Addendum #1

Attn: Estimator	Date: November 14, 2024
From: Lisa Donahue, Project Administrator	Pages: 58 (including cover page)
Re: Bullock Creek School District 2024 Bond Series 1	Project: 2025 Summer Projects HS/MS/Elem/Pine River/Floyd and Maintenance Building
CC:	Proj. #: A24907

Project: No. 24-120 2023 Bond – Series 1 2025 Improvements

Issue Date: November 14, 2024

NORTH
1/8" = 1'-0"
X01
RTU-B1 ENLARGED PLAN

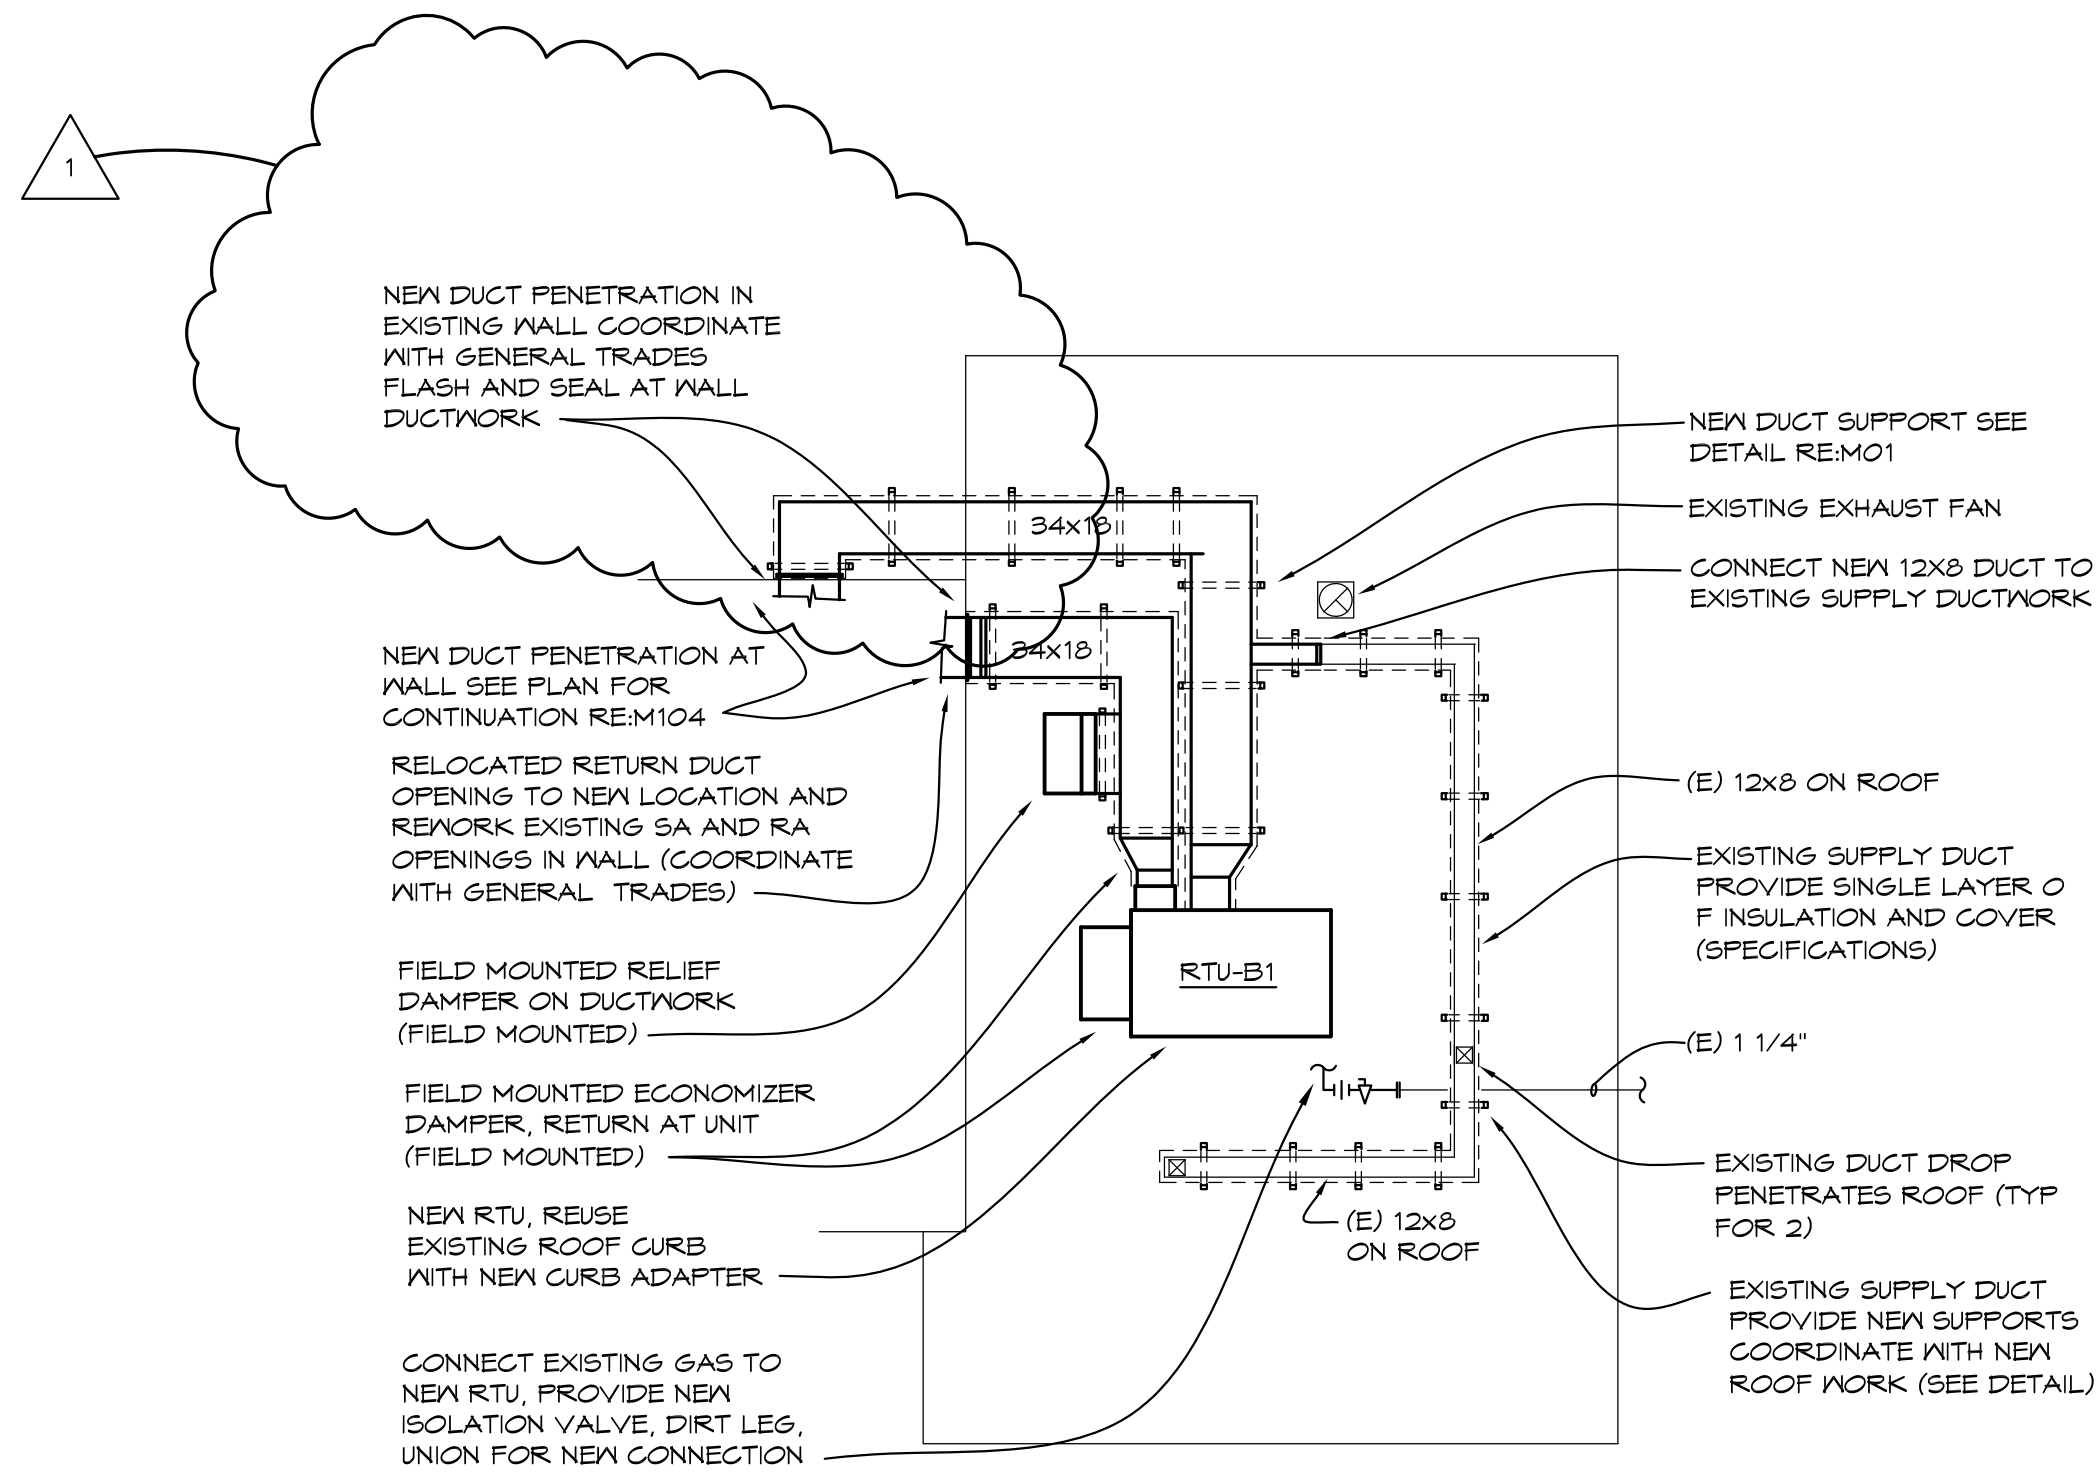
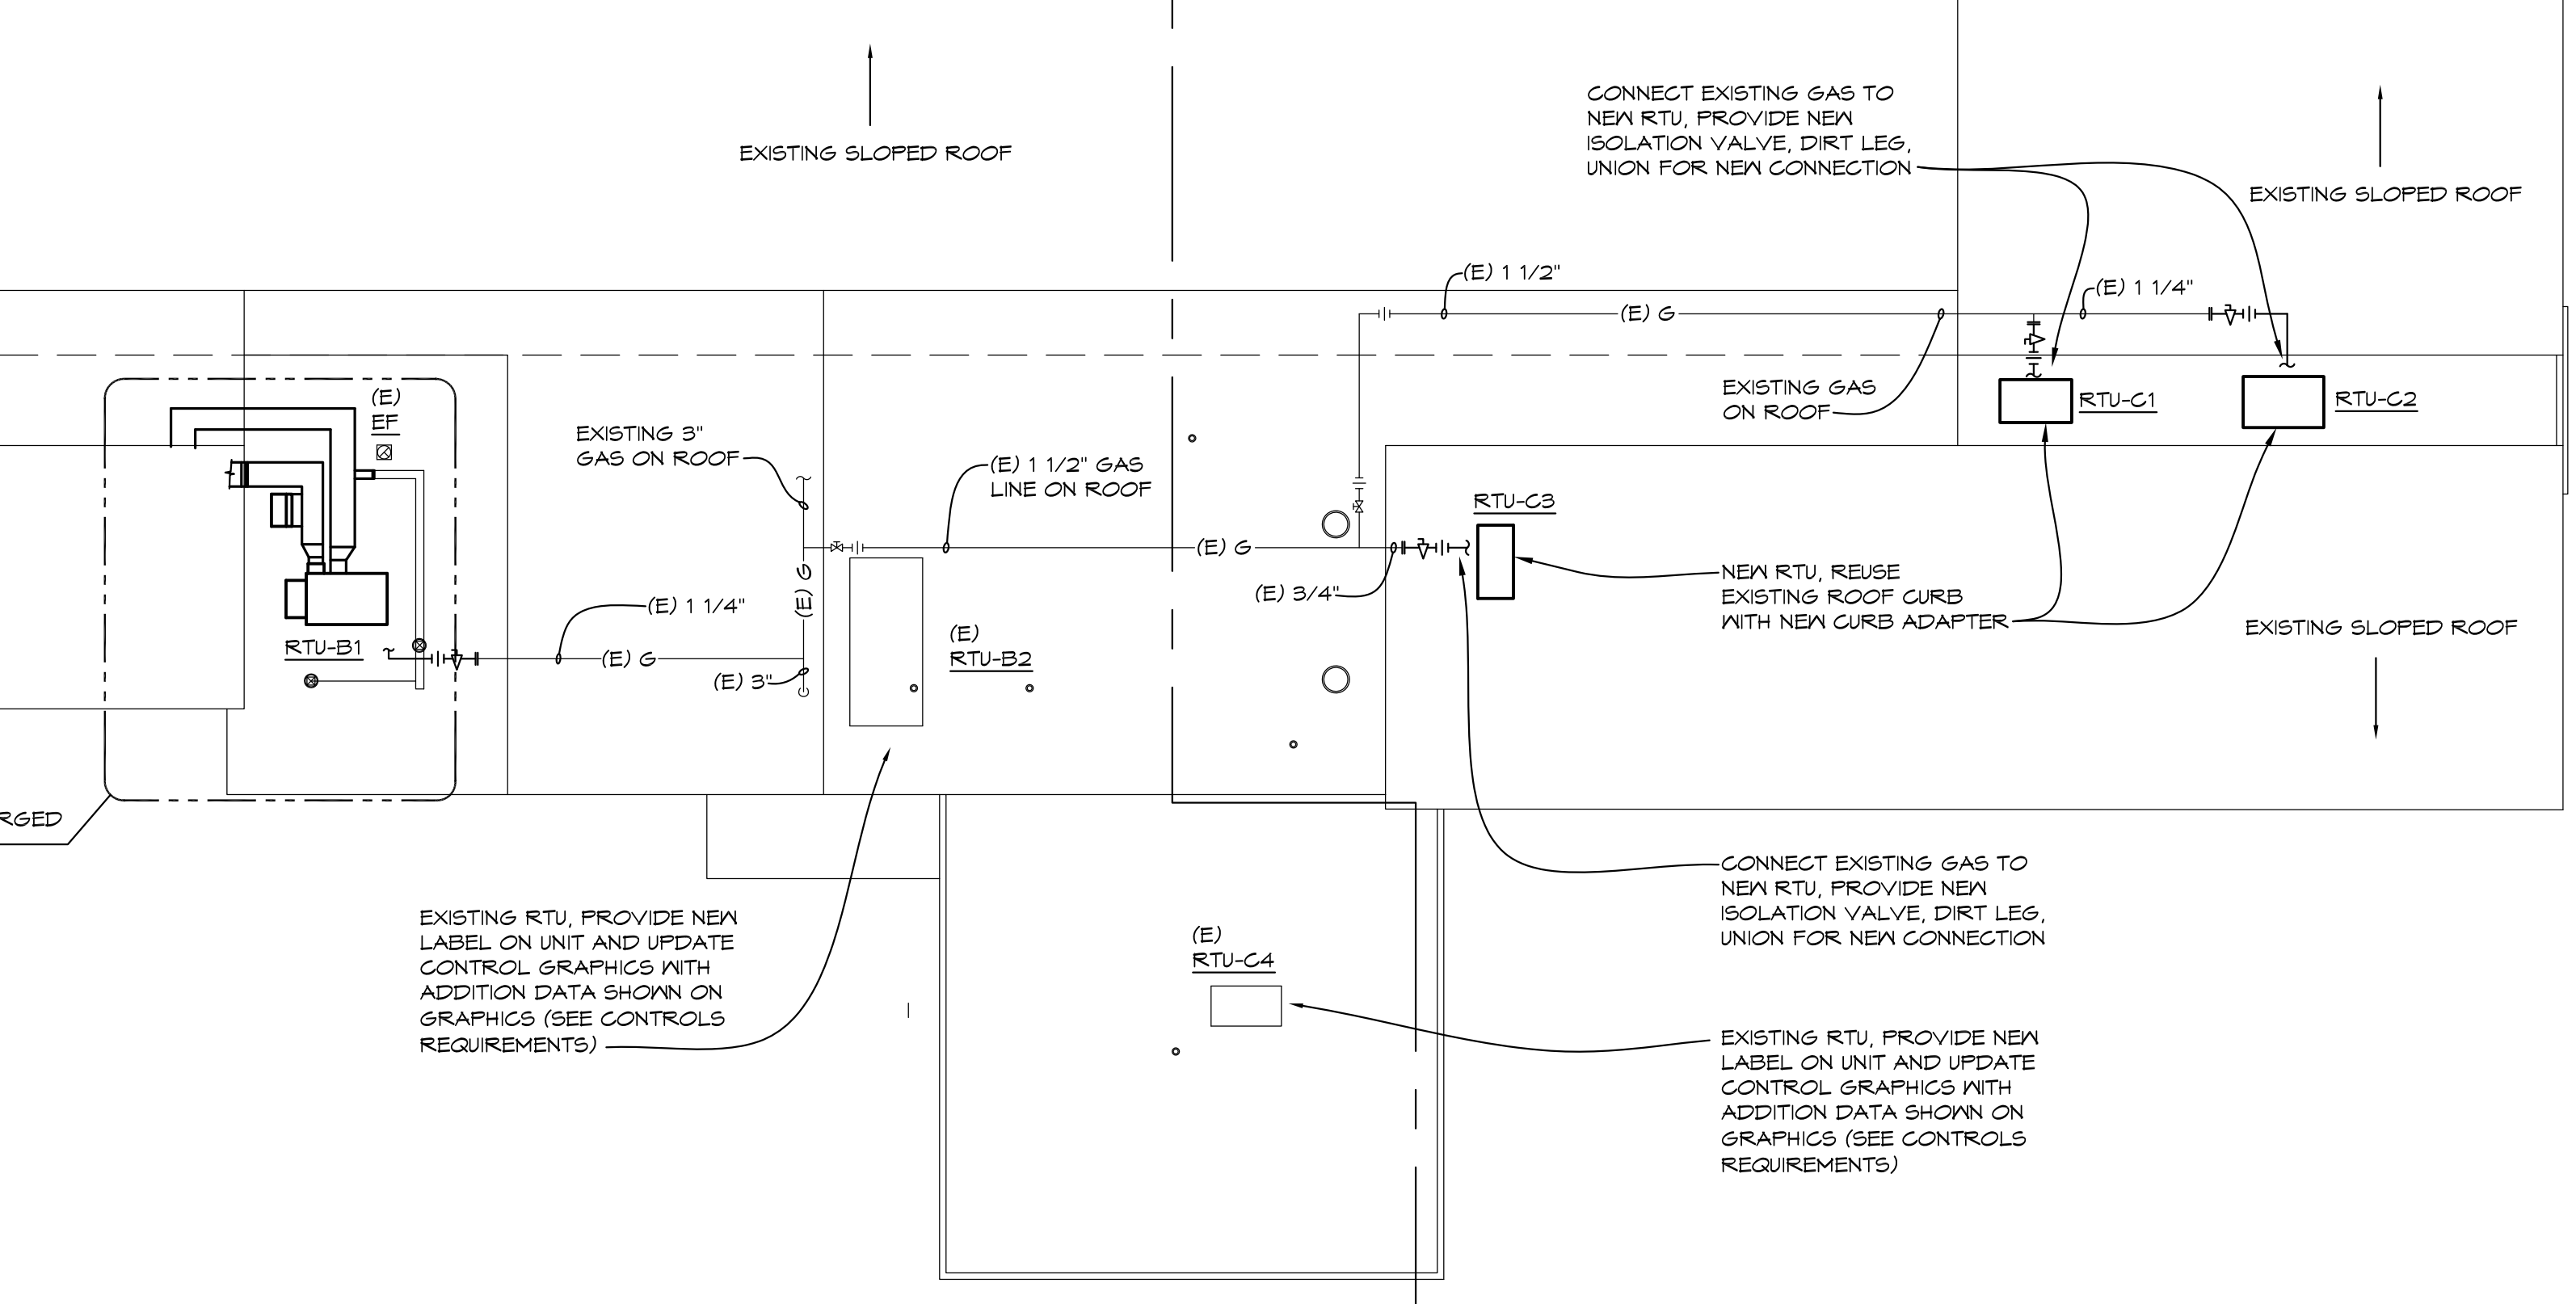
- Item #M1: Clarification for Sheet C-M101:
- a. Remove roof curb at heat recovery unit demolition. Coordinate with general trades/roofing contractor on infill of roofing insulation as part of new roof work.
- Item #M2: Raise existing 12x8 supply air ductwork on roof at RTU-B1 feeding 'teachers' lounge. Adjust drops for new roof curb heights. Provide insulation and support called out on plans.
- Item #M3: Raise existing gas line feeding RTU-B1 back to main line near RTU-B2 for new roofing work provide new nonpenetrating gas piping supports.
- Item #M4: Adjust 34X18 supply air duct penetration location as shown on Sheets C-M102 and C-M104. Coordinate with general trades for opening in wall.
